Technical Service Bulletin No. 35

Created by: Lab.gruppen AB Service Department

Reference no: Protective insulation on SP200PFC

5. Affected area

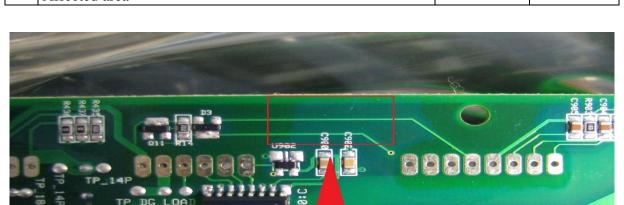
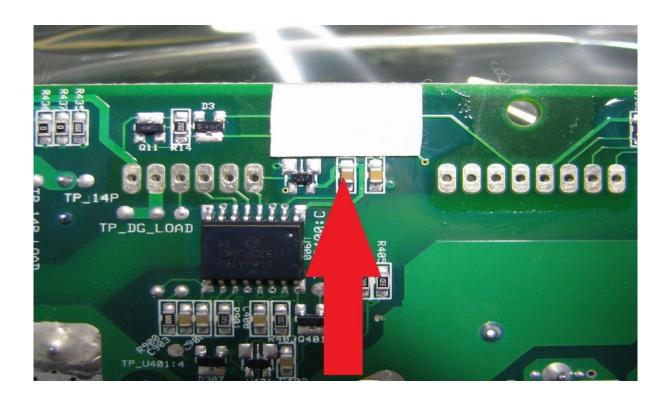
One of the top cover screws can scratch and break one of the leads on the SP200PFC09-board The display might *indicate* "PSU POWER PROTECT" warning

Attach adhesive insulation to the affected area to protect from future damage Try to repair if its damage

8. affected area with the board inside the amp

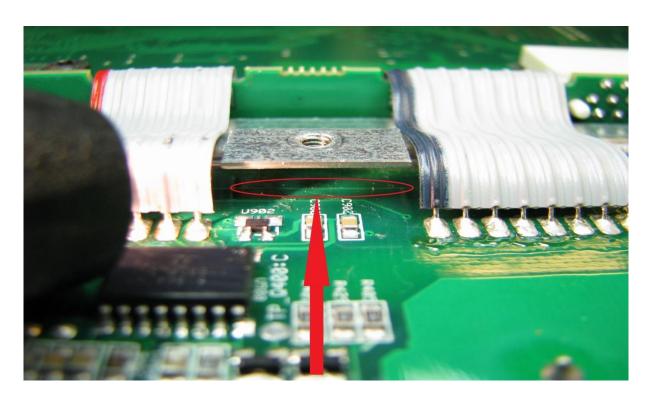
9. Check for scratches on the lead, if it is broken try to repair the lead before you continue to the next step
